FILE P.I. # 751420-
STP00-9252-00(007)
Fulton County
GDOT District 7 - Metro Atlanta
Johnson Ferry Road - Corridor Improvements

**DEPARTMENT OF TRANSPORTATION
STATE OF GEORGIA
PROJECT CONCEPT REPORT**

Roundabout Peer Review

Subject: RESPONSE TO ROUNDABOUT PEER REVIEW COMMENTS
Project No. STP00-9252-00(007)
P.I. No. 754120, Fulton County
COSS Project No. T-0011
Johnson Ferry Road and Glennridge Drive Connector Improvements

POTENTIAL VIEW ANGLE AND SIGHT DISTANCE ISSUES
SANDY SPRINGS, GEORGIA

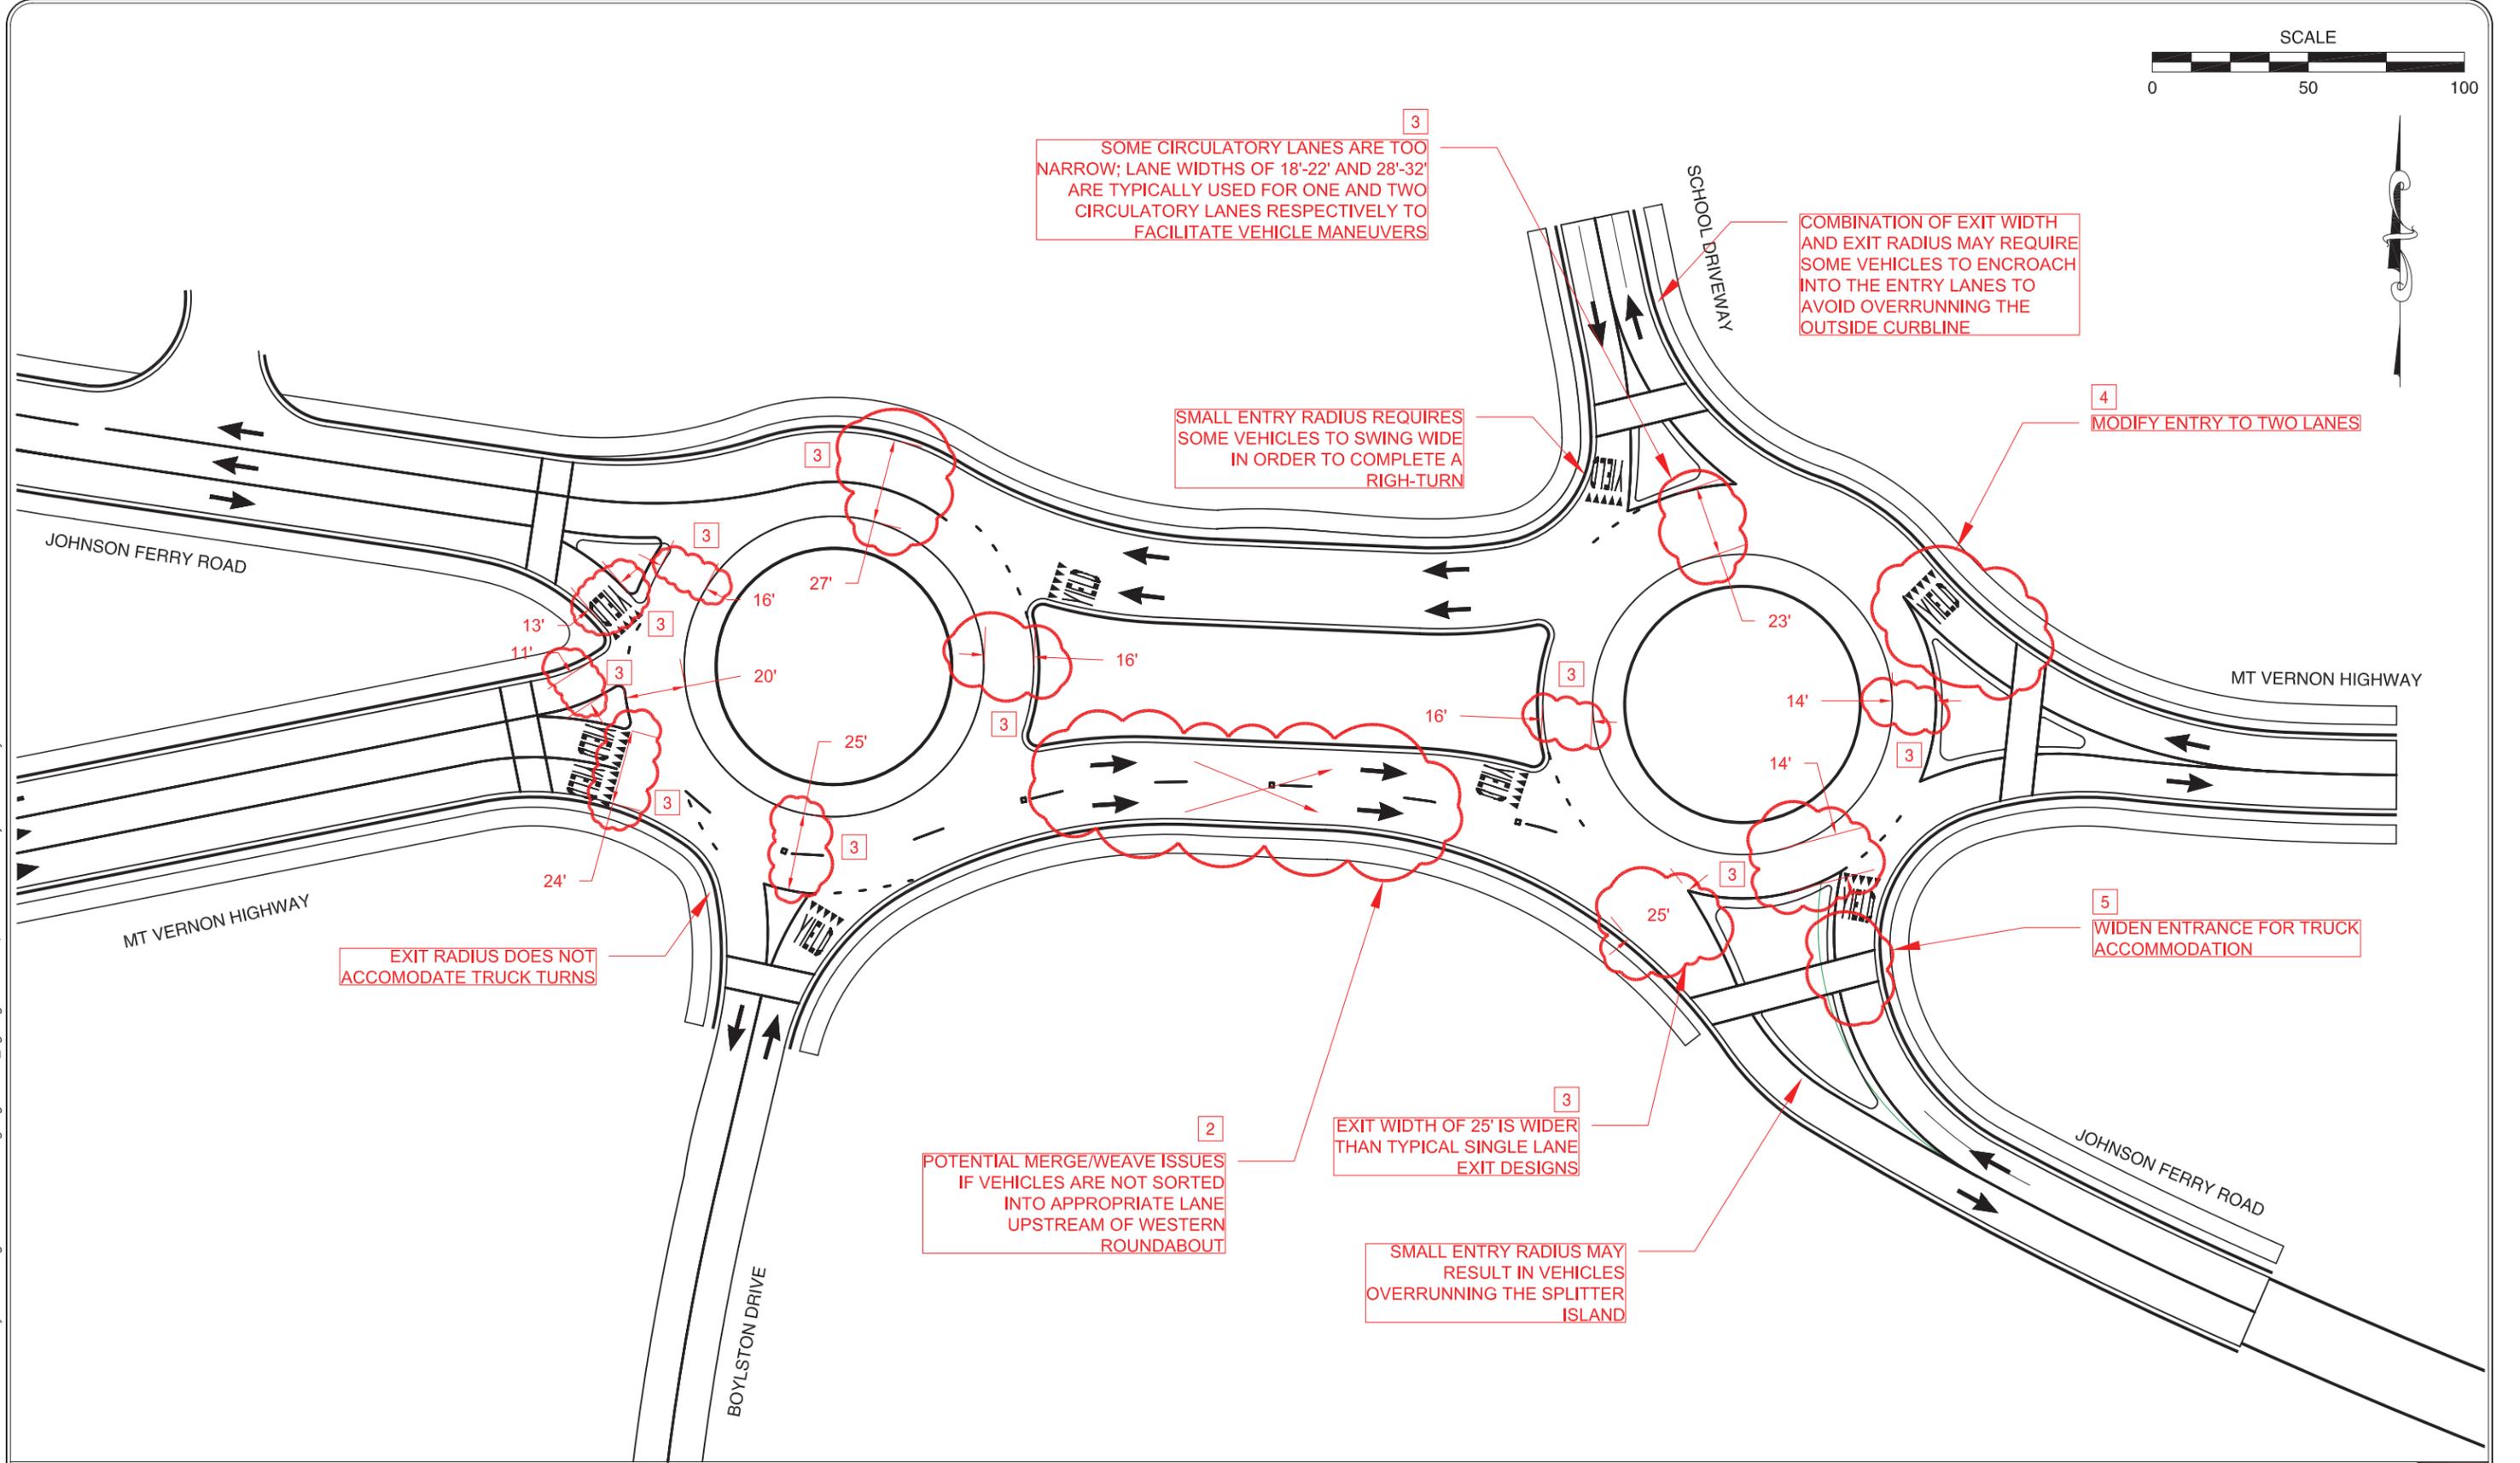
1. The two skewed eastbound approaches at the western roundabout do not provide sufficient separation for proper entry designs and vehicle yielding. As discussed previously, this may have both operational and safety implications. The angle between the two approaches does not permit the Mt. Vernon Highway entry to have proper visibility angles to the left. A view angle of less than 30 degrees is created as a result of the approach skew angle. As discussed in NCHRP 672, a minimum desirable intersection view angle of 75 degrees is recommended in order to allow drivers to comfortably turn their head to the left to view conflicting traffic on the immediate upstream entry. The angle of the entry also results in vehicles within the inner lane of the eastbound Mt. Vernon entry blocking visibility of the upstream entry and circulatory roadway for vehicles in the outside lane of the entry as illustrated in Figure 8. Relocation of the roundabout approximately 150 feet or more to the west may be needed to provide sufficient separation between entries. However, this pushes the roundabouts closer

2. At the western roundabout, relatively heavy through volumes from the eastbound approaches on Johnson Ferry Road and Mt. Vernon Highway may create weaving issues in the short section of roadway between the two roundabouts without additional guidance to drivers. As currently designed, the eastbound Johnson Ferry Road approach also seems to direct vehicles into the inside lane of the circulatory roadway, which would require a lane change for any vehicles wanting to make a right-turn at the downstream eastern roundabout. As discussed in the operational analysis portion of this report, weaving has operational implications that could increase the risk of queue spillback between roundabouts. Providing adequate signing to sort vehicles into the appropriate lane along Mt Vernon Highway prior to entering the western roundabout is important to minimize weaving. The signing will need to direct motorists into the appropriate lane (prior to entering the western roundabout) so that they can get to their desired exit downstream without additional lane changes.

3 SOME CIRCULATORY LANES ARE TOO NARROW; LANE WIDTHS OF 18'-22' AND 28'-32' ARE TYPICALLY USED FOR ONE AND TWO CIRCULATORY LANES RESPECTIVELY TO FACILITATE VEHICLE MANEUVERS

- At the western roundabout potential options for addressing the skew angle between the two eastbound approaches includes:
 - Relocate the western roundabout approximately 150 feet or more to the west. Doing so may allow for sufficient separation between the two eastbound entries to provide improved safety operations. This will not completely eliminate the view angle issues, but will help to separate out some of the conflict points. In addition, it will provide increased separation between the roundabouts to reduce the potential operational impact of weaving between the roundabouts. However, it will also reduce the storage distance between the roundabout and adjacent signalized intersections to the west, which will need to be further evaluated. If the roundabout was relocated, Boylston Drive would become a right-in/right-out stop-controlled intersection and northbound left-turns would be facilitated by vehicles turning right and then making a u-turn through the roundabout.

- Another possible option with the one-way couplet maintained would be to eliminate the west roundabout all-together. Under this scenario, Boylston Drive would become a right-in/right-out stop controlled intersection. This would eliminate the design issues associated with the western roundabout and provide additional distance from the signals for vehicles to get into the correct lane upstream of the eastern roundabout.

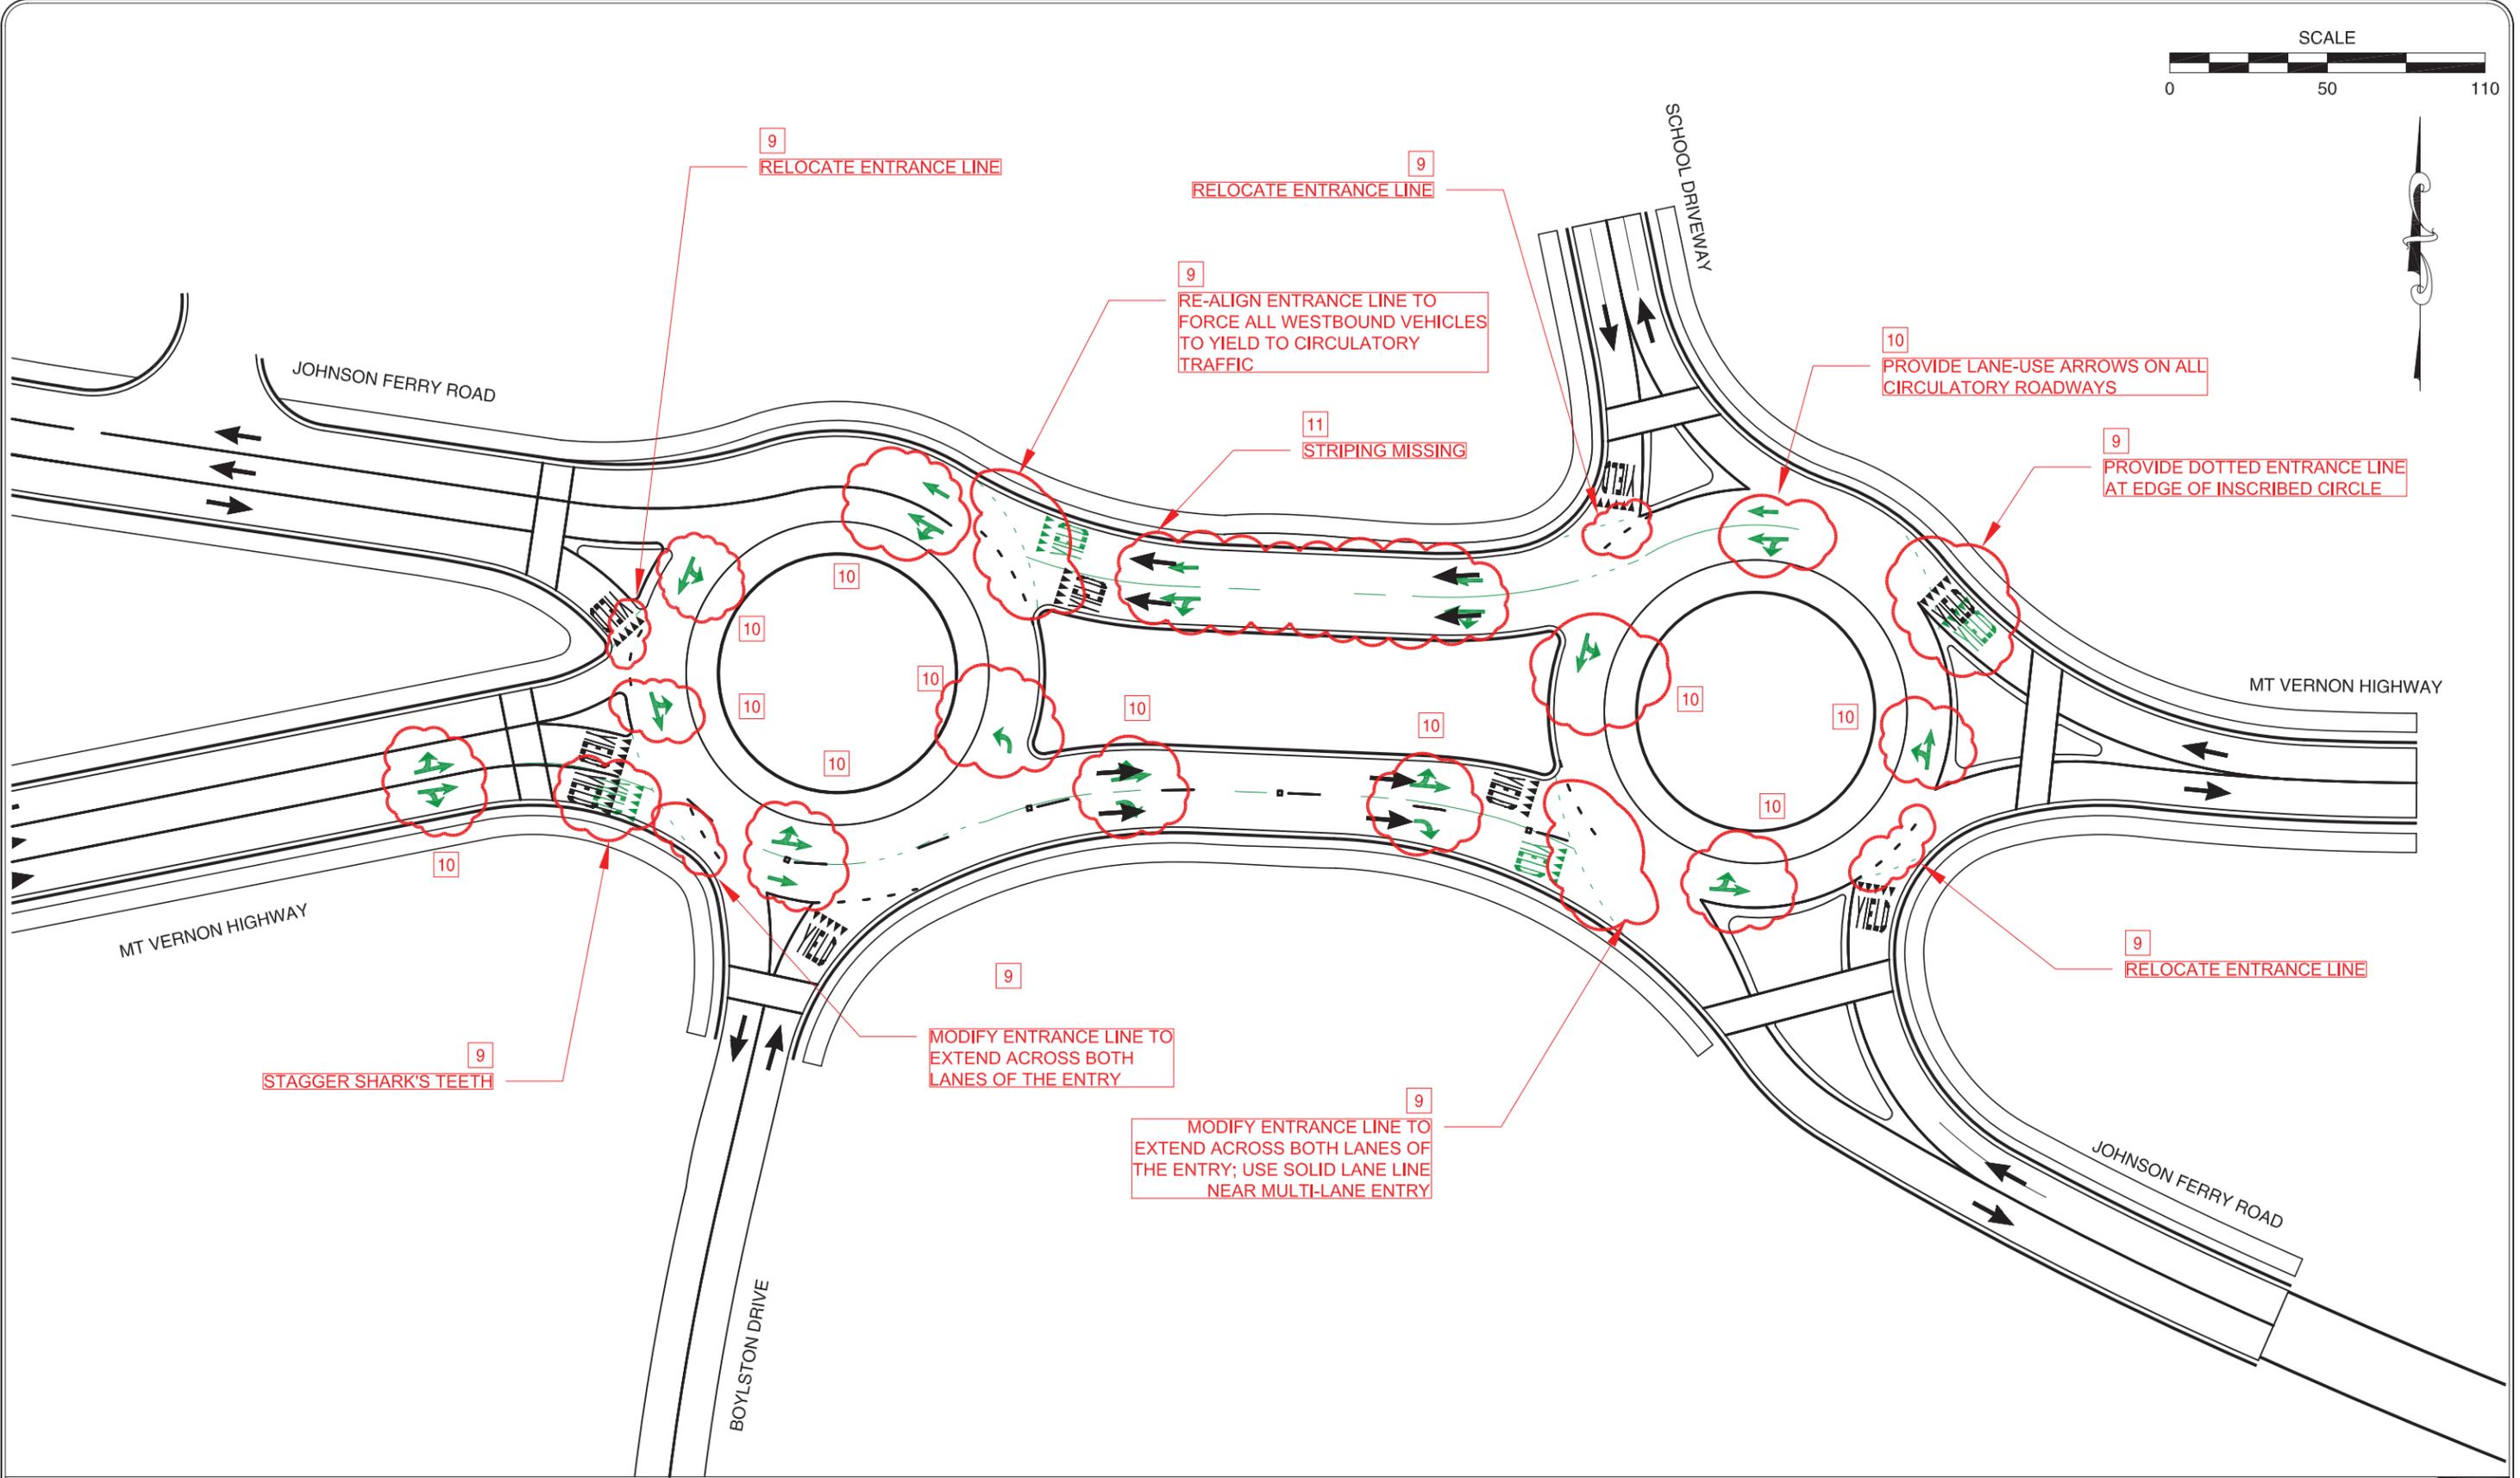
6. The eastbound Mt Vernon Highway entry at the western roundabout has the potential for entry path overlap. The entry geometry at the yield line positions vehicles in the outside lane such that they are aimed towards the inner lane of the circulatory roadway. NCHRP Report 672 provides additional guidance on entry design to improve the natural path alignment of vehicles. Modifications to the overall roundabout design (enlarged inscribed circle diameter or relocation of roundabout to the west) is likely necessary in order to implement changes to the approach alignment and geometry to meet design objectives.

8. On the westbound entry at the eastern roundabout, the entry aligns vehicles into the outside lane of the circulatory roadway. Meanwhile, the single-lane portion of the circulatory roadway aligns vehicles such that they stay within the inner lane as the circulatory roadway widens out to two lanes. This suggests to drivers that the westbound entry is “free-flow” and isn’t required to yield. However, a conflict is created for drivers that are trying to exit onto the driveway on the north leg of the roundabout if westbound vehicles do not yield. Design modifications should emphasize yielding of entering vehicles to all vehicles circulating past the westbound entry.

6
POTENTIAL PATH OVERLAP ISSUES;
VEHICLES IN THE OUTSIDE LANE ARE
POSITIONED TOWARDS THE INSIDE
LANE OF THE CIRCULATORY ROADWAY
AT THE ENTRANCE LINE

7
DRIVERS MAY PERCEIVE THE RIGHT-TURN AS FREE FLOW
DUE TO THE SWEEPING OUTSIDE CURB RADIUS WHICH
COULD RESULT IN CONFLICTS WITH EXITING VEHICLES;

THE ALIGNMENT OF THE RIGHT-TURN LANE AT THE YIELD
LINE AIMS VEHICLES INTO THE CIRCULATORY ROADWAY
WHICH COULD RESULT IN ENTRY PATH OVERLAP IF
VEHICLES INTO THE OUTSIDE LANE FAIL TO RECOGNIZE
THAT THE OUTSIDE LANE IS A RIGHT-TURN ONLY.

- The addition of a second entry lane to the westbound approach of the eastern roundabout will further reduce the speed control unless additional geometric modifications are provided (such as offsetting the approach alignment to the left of the roundabout center, increasing the inscribed circle diameter, etc.). Offsetting the approach alignment to the left of the roundabout center and using a larger radius or tangential exit is one option to explore to provide additional space for adding another westbound entry lane while also potentially maintaining entry speed control. However, modifications to the exit on the east leg may also exacerbate the issues for accommodating the design vehicle making a northbound right-turn at the eastern roundabout. Reducing the width of the splitter island on the northbound approach may assist in improving the northbound right-turn truck accommodation.
